Metro Outer Joint Development Assessment Panel Agenda

Meeting Date and Time: Friday, 7 May 2021; 9:30am
Meeting Number: MOJDAP/84
Meeting Venue: City of Rockingham
Civic Boulevard, Rockingham

Development Description: Mixed commercial development
Applicant: Planning Solutions
Owner: Peet Golden Bay
Housing Authority
Responsible Authority: City of Rockingham
DAP File No: DAP/21/01952

**LOT 265 TALISKER BEND, GOLDEN BAY
DEVELOPMENT APPLICATION – PROPOSED MIXED COMMERCIAL DEVELOPMENT
RESPONSE TO REQUESTS FOR FURTHER INFORMATION**

Figure 4. Trees identified for retention

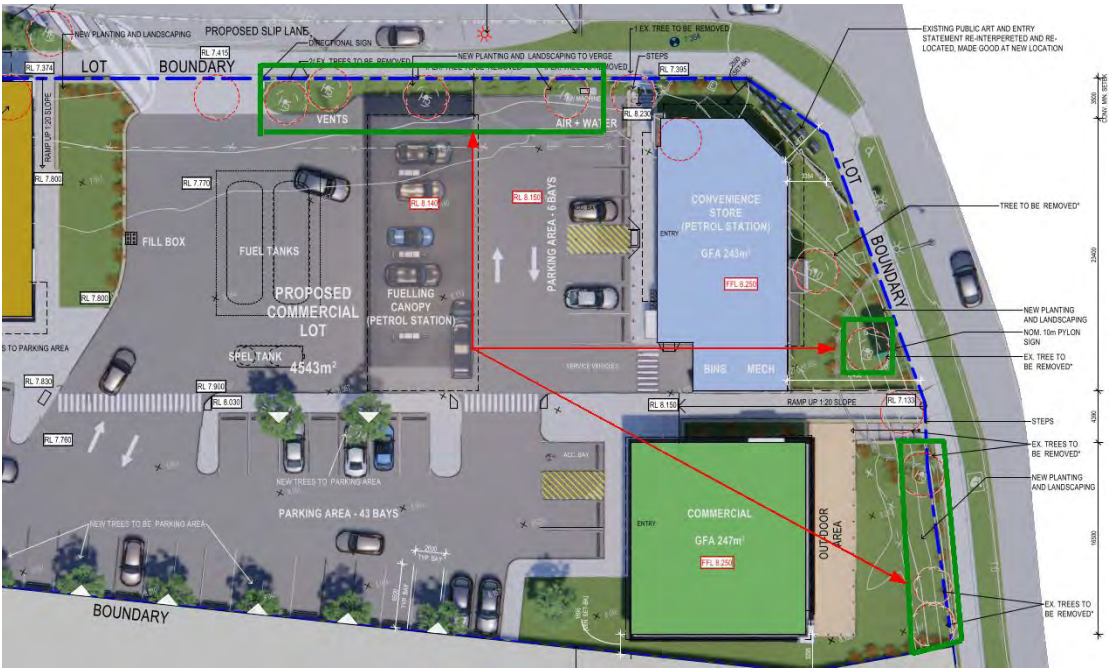
A balanced approach has not been considered by the applicant, as the majority of the vegetation screen are sought to be unnecessarily removed in order to allow for unimpeded views of the fuel retailing building and its associated signage.

The trees proposed to be removed are not remnant vegetation. Nevertheless, the City seeks to retain several established trees and minimise clearing wherever possible. Further, the existing vegetation is considered likely to provide visual relief from the public realm. It is recommended that eight (8) out of the 16 trees identified for removal as illustrated in Figure 4 below be retained, in the event development is approved.

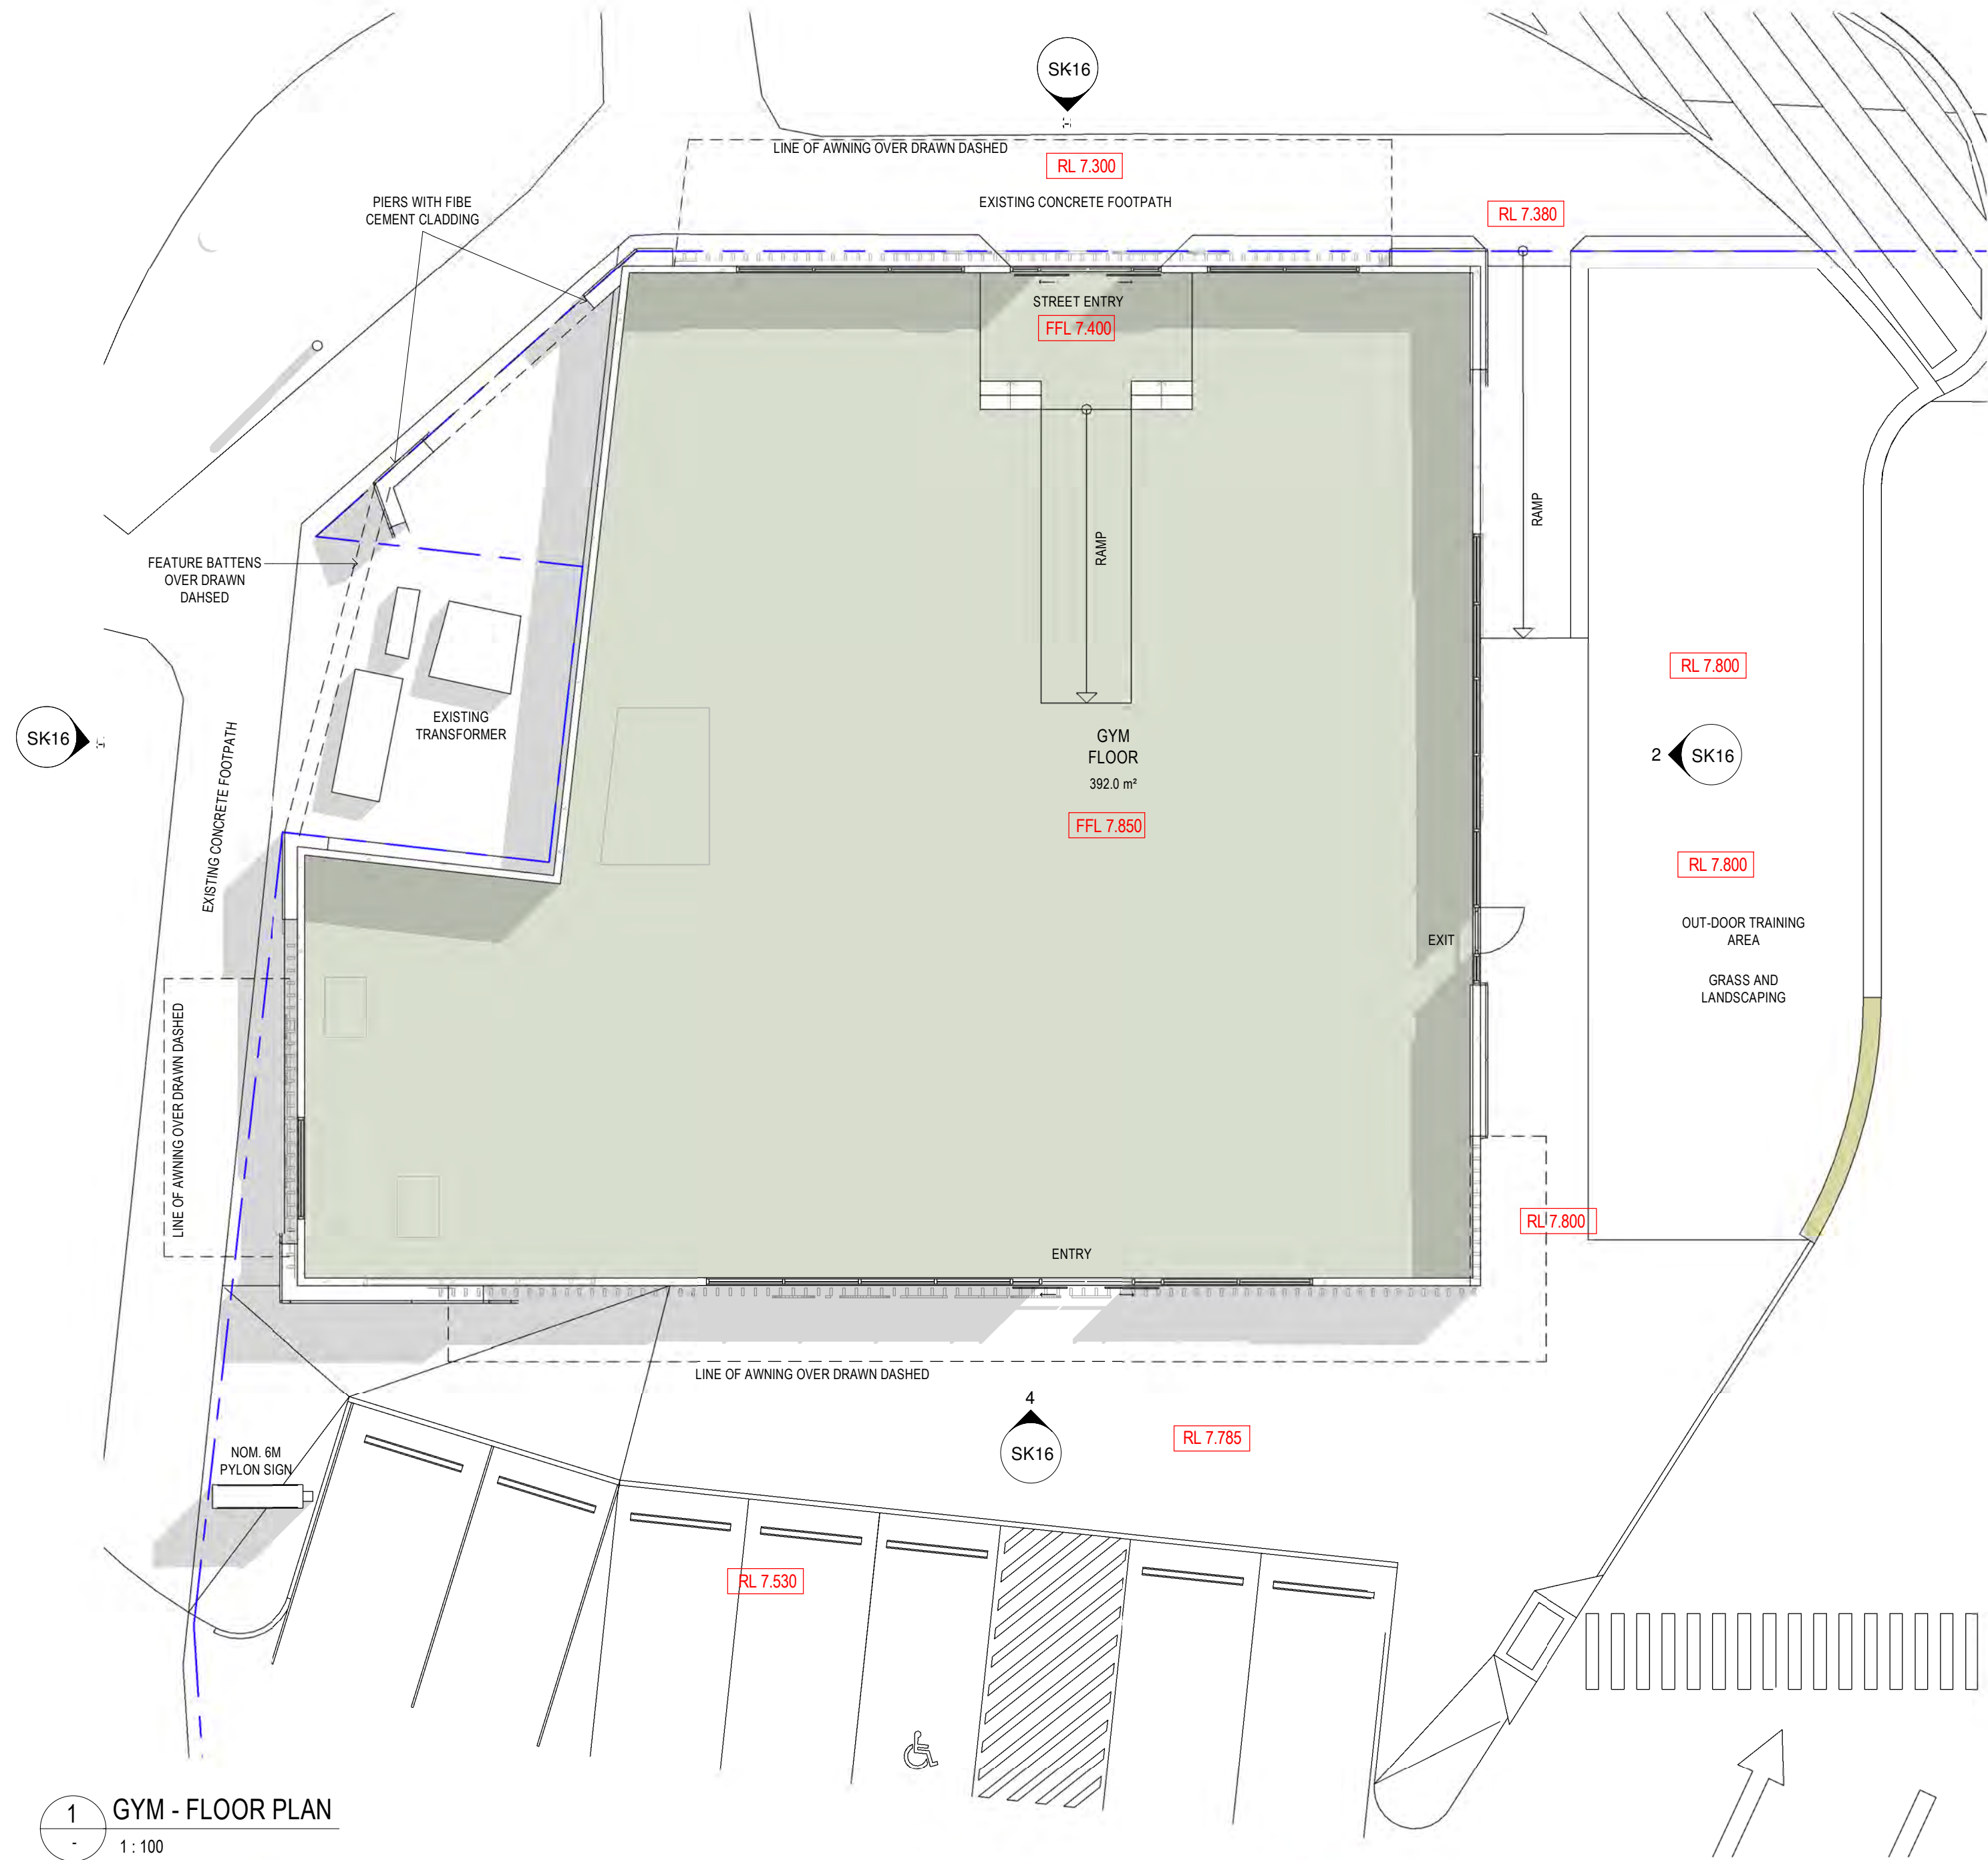
City's comment	Applicant response
4. Consider relocating the Air/Water bay by removing one adjacent standard car parking bay adjoining the air/water bay, utilising the wider pavement nib provided in this location for additional circulation space. This change is requested to ensure that three (3) existing advanced Casuarina equisetifolia trees to Aurea Blvd can be retained.	<p>This has been considered in the design of the facility, however, it cannot be accommodated. The air & water bay is logically located to the north of the service station car parking bays and is aligned to ensure no impediment on the vehicle accessway or any vehicle flows from the fuel canopy area.</p> <p>If the trees requiring removal cannot be relocated, they will be replaced (in a new location) by an advanced tree of the same or similar species.</p>

5. Reduce the garden area wrapping the Western corner of the proposed gymnasium to remove all small slender garden beds, as they will likely be subject to vandalism and the overhead canopy will provide no natural rain to planting, ultimately gardens will be high maintenance.	Please refer to Attachment 2 for the revised development plans. The narrow landscaping strips adjacent to the gymnasium (and covered by the awnings) have been removed and replaced with paving for ease of maintenance purposes.

6. Infill pavement surrounding the existing transformer infrastructure to reduce ongoing maintenance.	Please refer to Attachment 2 for the revised development plans. The existing transformer is proposed to be surrounded by pavement.

7. Remove the extension of the pathway connection along the front of the proposed commercial tenancies, as no external access is proposed to the Southern corner of the building.	Please refer to Attachment 2 for the revised development plans. The portion of pathway adjacent to the commercial tenancy extending south has been removed and replaced with soft landscaping / planting.

8. Provide triangular tree planting nibs to all proposed tree planting areas within carparks.	Please refer to Attachment 1 for the revised development plans. The site plan and landscape sketch now show the tree wells between car parking bays. Each tree well is proposed to contain a Casuarina equisetifolia tree.
Engineering and Traffic
